MY 2023 - 2024 Jeep Grand Cherokee (WL) - Removal of the Engine Cover on 3.6L Engines

MY 2025 RAM 1500 Pickup (DT) – Commonization of Carryover Jeep Wrangler (JL)/Jeep Gladiator (JT) Oil Fill Neck Into DT on 3.6L Engines

MY 2025 ProMaster (VF) - 12 Volt Battery

Figure 1: Overhead view of the WL 3.6L Engine without the engine cover

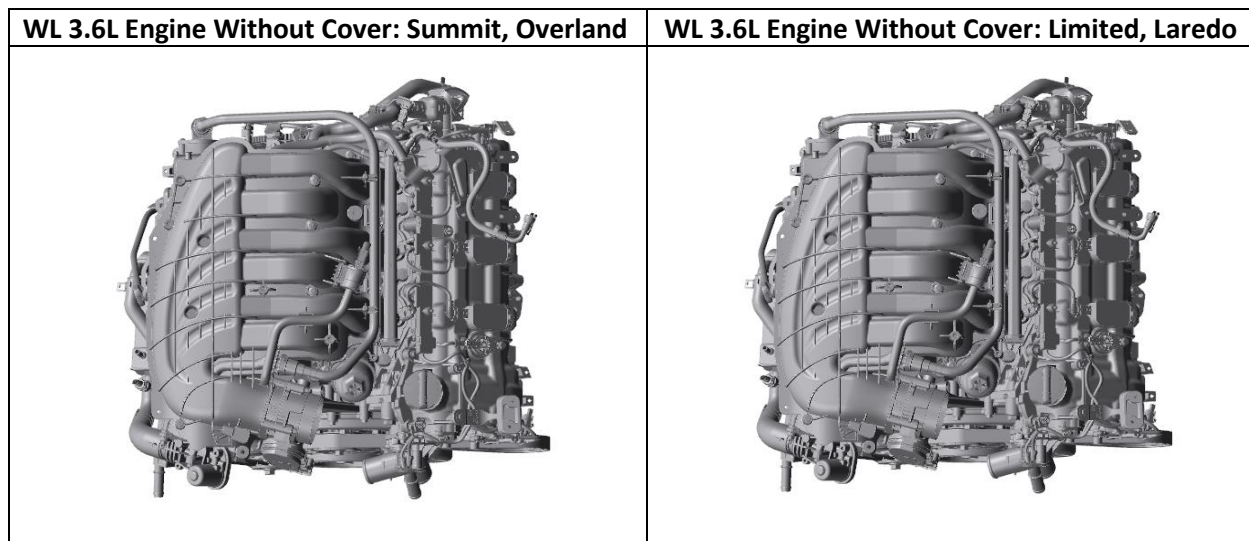
The removal of the engine cover for WL in the

Summit and Overland trim grades has been in effect since January 17th, 2024. WL with the 3.6L engine, the engine cover **DOES NOT** apply to the **Summit, Overland, Laredo, and Limited** trim grades. The engine covers have been removed from these vehicles. Please note that this notice is **NOT** applicable to the other engine variants, which currently receive an engine cover.

Figure 1: Visual reference of before and after

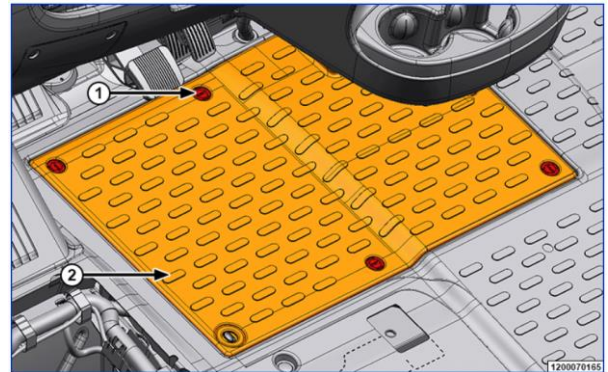
To make the service community aware of the change on PSU 3.6L DT vehicles, the FCA US Service team is working to notify the extended dealer network regarding the change on the oil fill neck for 3.6L DT.

The change of implementing the JL/JT oil fill neck into DT family will take place beginning with Engine Build dates from 06/16. The intention is to make you aware of this change.

Picture of Defect

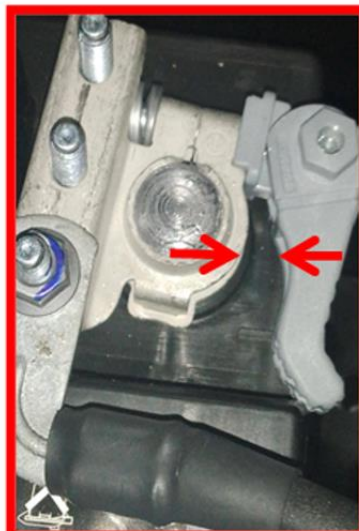
- 12-Volt Battery Negative Post Clamp not closed, with contact with the plastic

battery casing.

- Negative post clamp position not fully down.

Negative post clamp position not fully closed.

Not Fully down.

Picture of Good connection

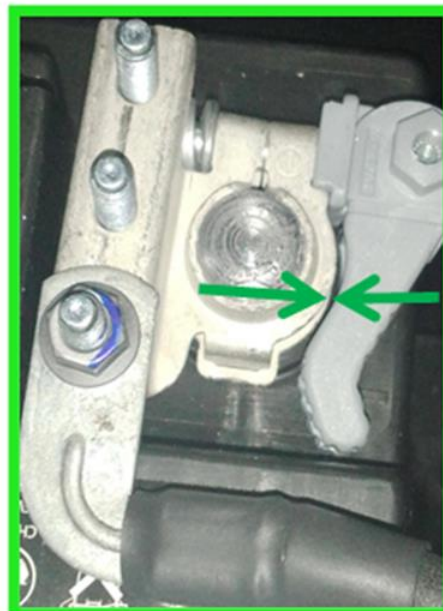
- Fully closed 12-Volt battery negative post clamp, no contact with the plastic battery casing.
- Negative post clamp position fully down.

Negative post clamp position fully closed.

Fully down.
